# Access Compliance Report

## Public Rights-of-Way

### (Curb Ramps)

Intersection ID: 51473	Main Street: LILLIESLEAF_GLENN_LN	Cross Street: TAMARRON_DR	Location:	N
ADA ID: 554B80BF99D2	Ramp Type: PerpDiag	Initial Pass/Fail: Fail	Overall Compliance: No	Severity Score: 8.75

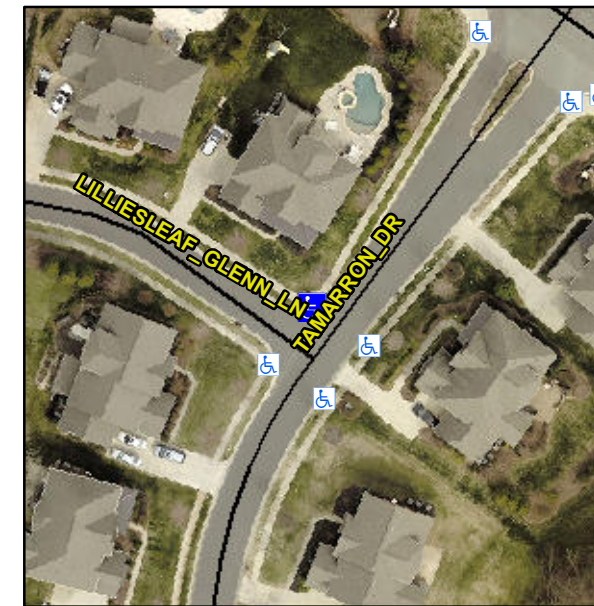
**Not Found, R304.5.1**

Compliance	Description	Data	Compliance	Description	Data
N/A	Ramp Length (in)	51.0	Yes	Ramp Slope (%)	5.0
No	Ramp Width (in)	47.0	Yes	Ramp XSlope (%)	1.2
N/A	Flare Type LT	N/A	N/A	Flare Type RT	N/A
N/A	Flare Slope LT (%)	N/A	N/A	Flare Slope RT (%)	N/A
N/A	Flare Traversable LT?	N/A	N/A	Flare Traversable RT?	N/A
N/A	Landing Length (in)	N/A	N/A	DWS Provided?	N/A
N/A	Landing Width (in)	N/A	N/A	DWS Contrast?	N/A
N/A	Landing Slope (%)	N/A	N/A	DWS Length (in)	N/A
N/A	Landing X Slope (%)	N/A	N/A	DWS Full Width?	N/A
N/A	Landing Curb? (Y/N)	N/A	N/A	DWS Offset (in)	N/A
N/A	Shared Landing?	N/A			
N/A	Gutter Ponding?	N/A	N/A	Gutter Slope (%)	N/A
N/A	Gutter Lip Ht (in)	N/A	N/A	Gutter X Slope (%)	N/A
N/A	Painted X Walk1?	No	N/A	Painted X Walk2?	No
	X Walk 1 Direction	To SW		X Walk 2 Direction	To SE
N/A	X Walk 1 Width (in)	N/A	N/A	X Walk 2 Width (in)	N/A
	X Walk 1 Slope (%)	0.4		X Walk 2 Slope (%)	2.2
	X Walk 1 X Slope (%)	2.6		X Walk 2 X Slope (%)	1.1

**Remove & Replace Curb Ramp With Two New Directional Ramps or Equivalent.**
